Access Compliance Report

Public Rights-of-Way

Intersection ID: 28312	Main Street: KRISHNA_LN	Cross Street: OLD_ARDREY_KELL_RD	Location: SW
ADA ID: 72DADA8490B6	Ramp Type: PerpDiag	Initial Pass/Fail: Fail	Overall Compliance: No
		Severity Score: 12.5

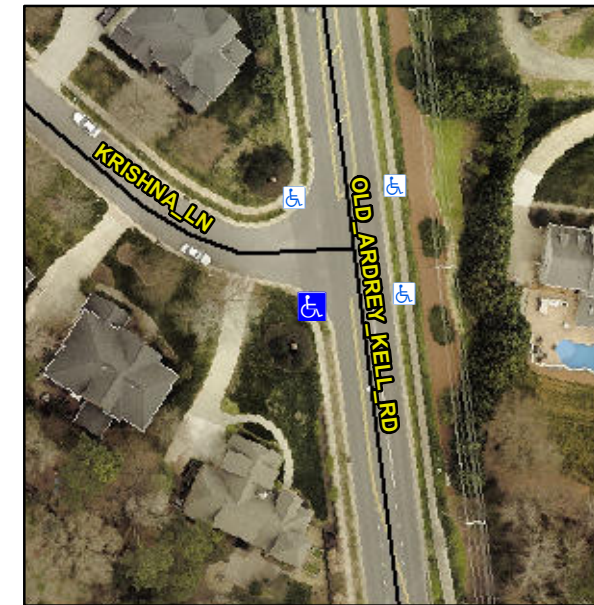
Not Found, R304.2.2

Compliance	Description	Data	Compliance	Description	Data
N/A	Ramp Length (in)	47.5	No	Ramp Slope (%)	8.9
Yes	Ramp Width (in)	53.0	Yes	Ramp XSlope (%)	2.0
N/A	Flare Type LT	N/A	N/A	Flare Type RT	N/A
N/A	Flare Slope LT (%)	N/A	N/A	Flare Slope RT (%)	N/A
N/A	Flare Traversable LT?	N/A	N/A	Flare Traversable RT?	N/A
N/A	Landing Length (in)	N/A	N/A	DWS Provided?	N/A
N/A	Landing Width (in)	N/A	N/A	DWS Contrast?	N/A
N/A	Landing Slope (%)	N/A	N/A	DWS Length (in)	N/A
N/A	Landing X Slope (%)	N/A	N/A	DWS Full Width?	N/A
N/A	Landing Curb? (Y/N)	N/A	N/A	DWS Offset (in)	N/A
N/A	Shared Landing?	N/A			
N/A	Gutter Ponding?	N/A	N/A	Gutter Slope (%)	N/A
N/A	Gutter Lip Ht (in)	N/A	N/A	Gutter X Slope (%)	N/A
N/A	Painted X Walk1?	No	N/A	Painted X Walk2?	No
	X Walk 1 Direction	To E		X Walk 2 Direction	To N
N/A	X Walk 1 Width (in)	N/A	N/A	X Walk 2 Width (in)	N/A
	X Walk 1 Slope (%)	0.7		X Walk 2 Slope (%)	1.0
	X Walk 1 X Slope (%)	0.9		X Walk 2 X Slope (%)	0.3

Remove & Replace Curb Ramp With Two New Directional Ramps or Equivalent.
